ENVIRONMENTAL COMMITTEE MEETING

January 7, 2026

Subject: Review of redevelopment plans for 150 Thompson Ave. E.

Review submitted plans for the redevelopment of the 424 Butler Avenue East property.

DRAWING N°
 C-5

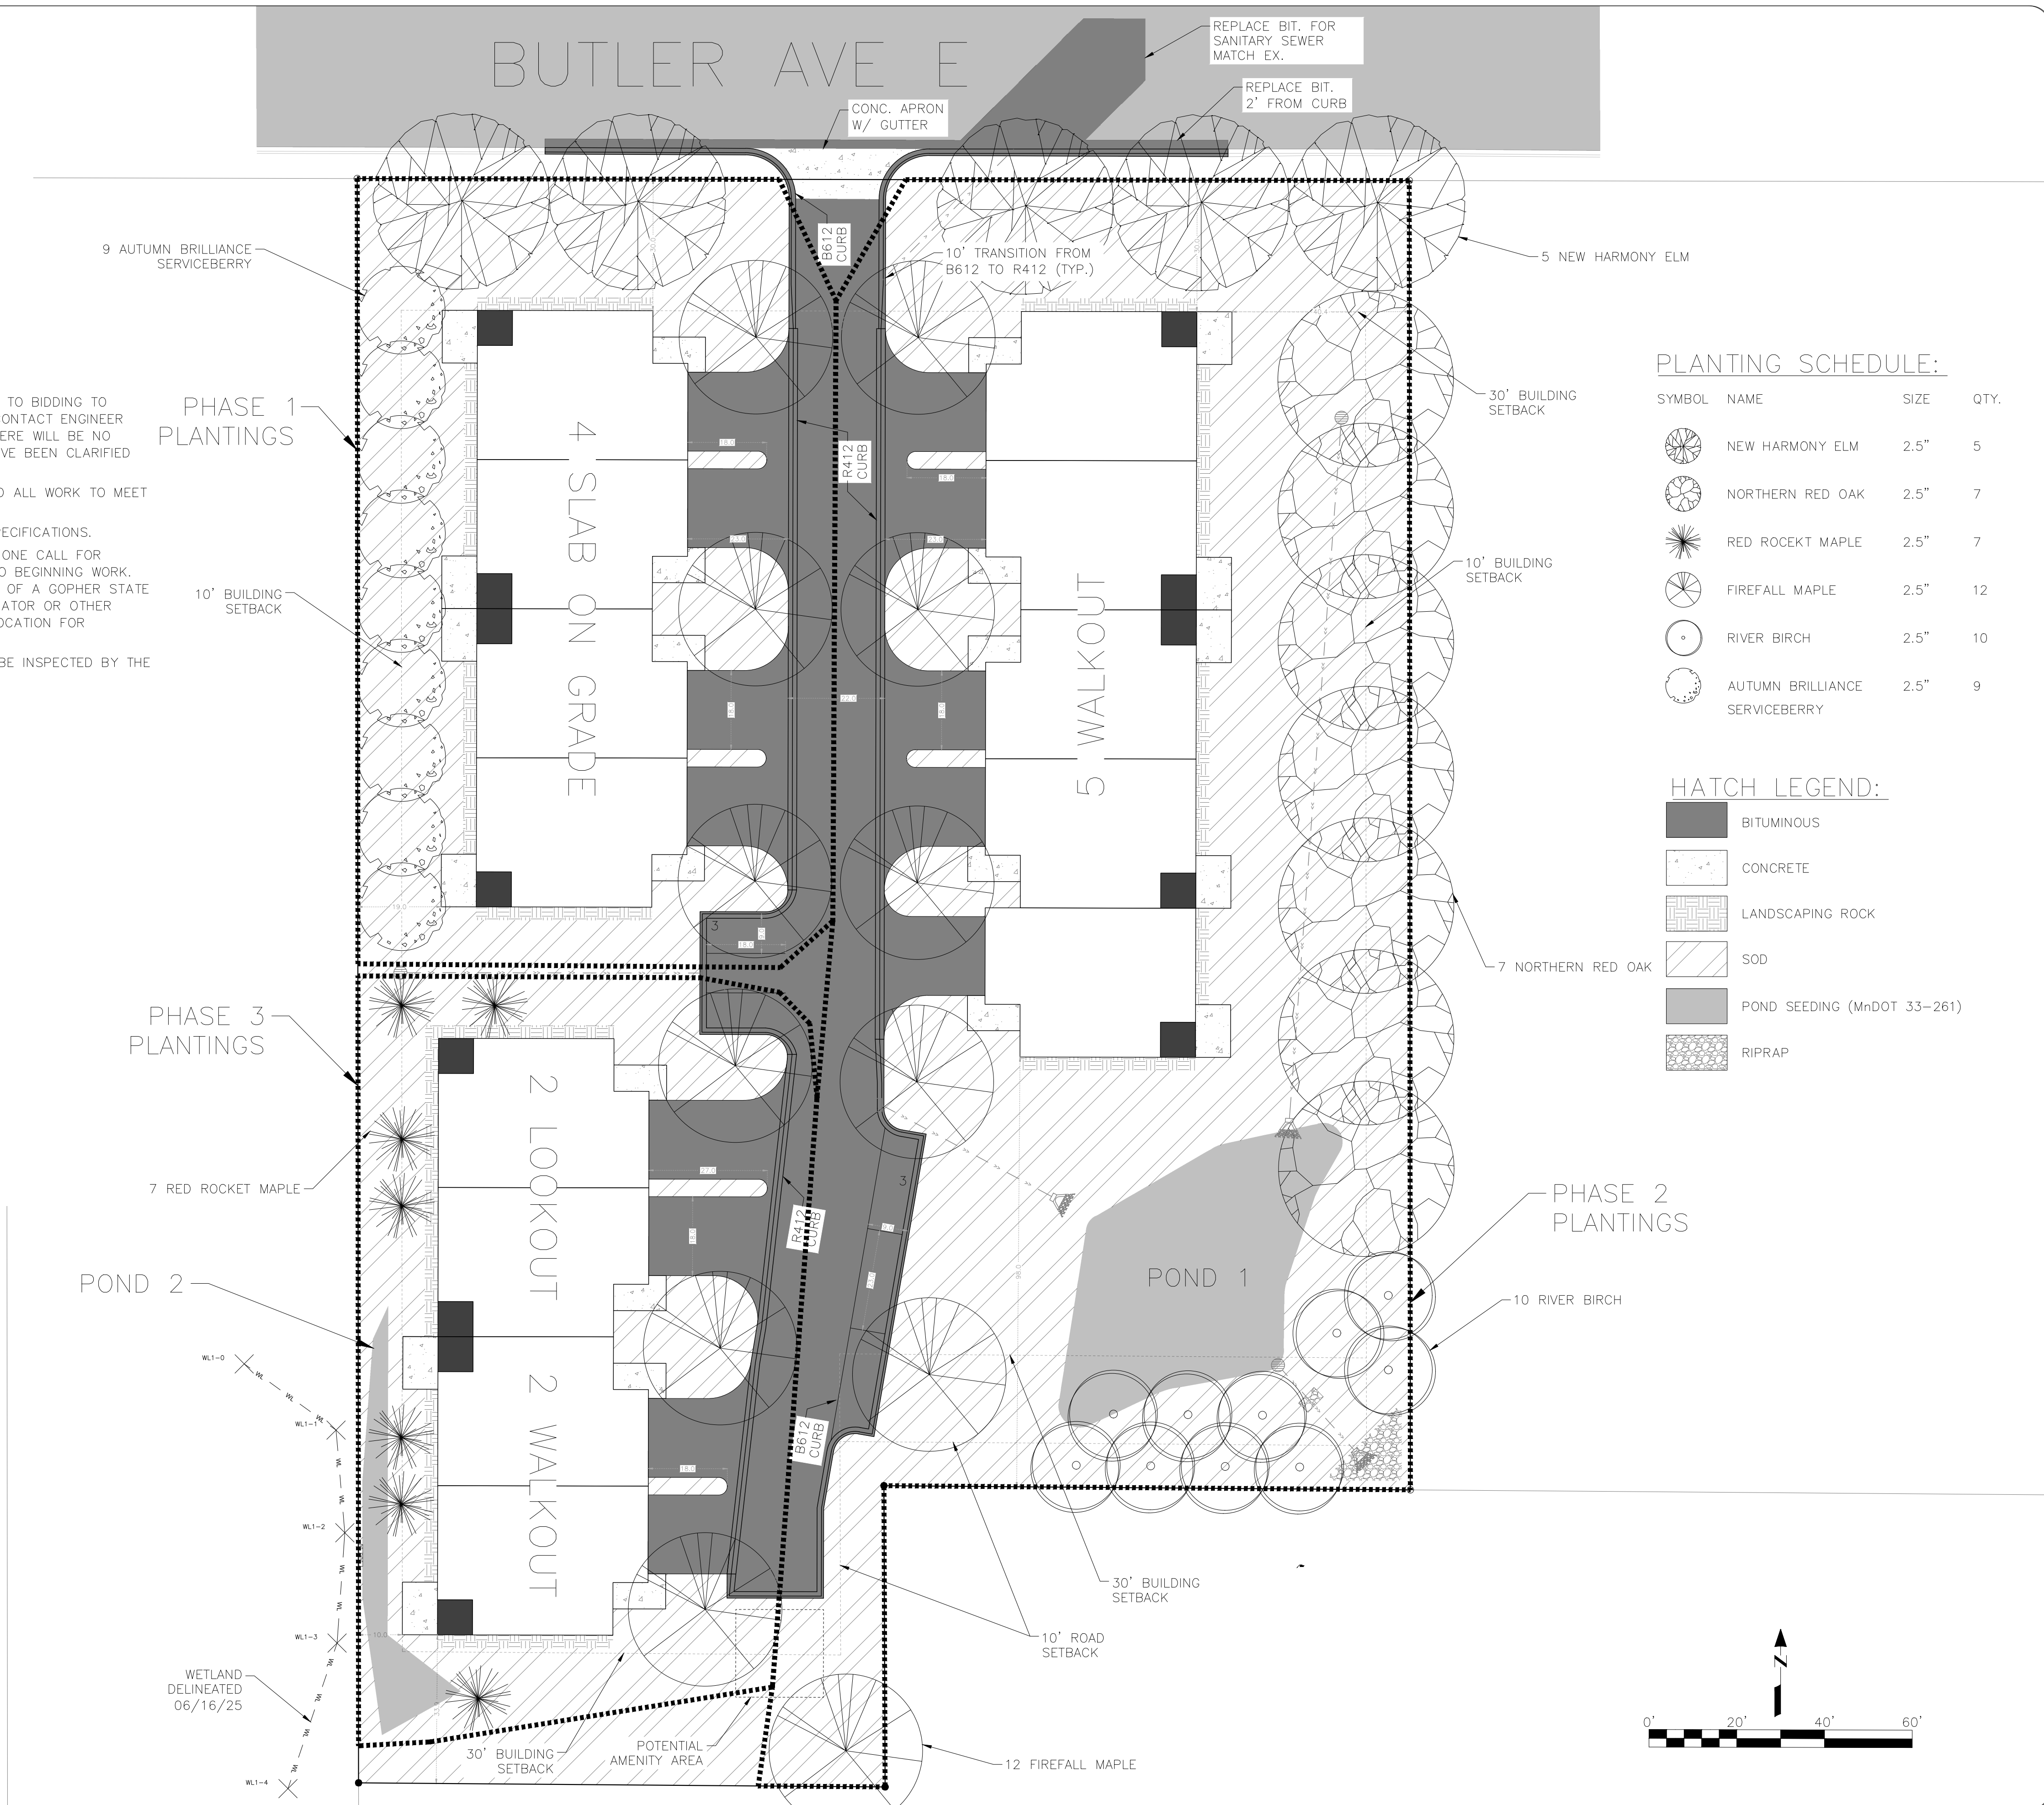
The list below includes the initial proposal for new plantings on the site. Staff has crossed out the initially proposed plantings (shown by the ~~double-strike through~~) and added alternative plantings in red text as well as recommended additional plantings.

Staff is also recommending that the size of trees be increased from 2.5 caliper inches up to 3 inches. This brings the number of proposed trees/caliper inches for the site to 57 trees and 171 caliper inches. As these numbers fall below the minimum requirement (144 trees/359 inches), staff is requesting feedback from the commission on where additional trees might be planted as well as recommended types.

- All trees are to be increased in size from 2.5 caliper inches to 3 caliper inches.
- The seven Northern Red Oak trees are to be replaced with three Bur Oak and four Swamp White Oak trees.
- The seven Red Rocket Maple trees are to be replaced with three Common Hackberry and four Honey Lotus trees.
- The 12 Firefall maple trees are to be replaced with six Black cherry and six Little Leaf Linden trees.

- The plans shall include an additional seven Red Cedar trees.
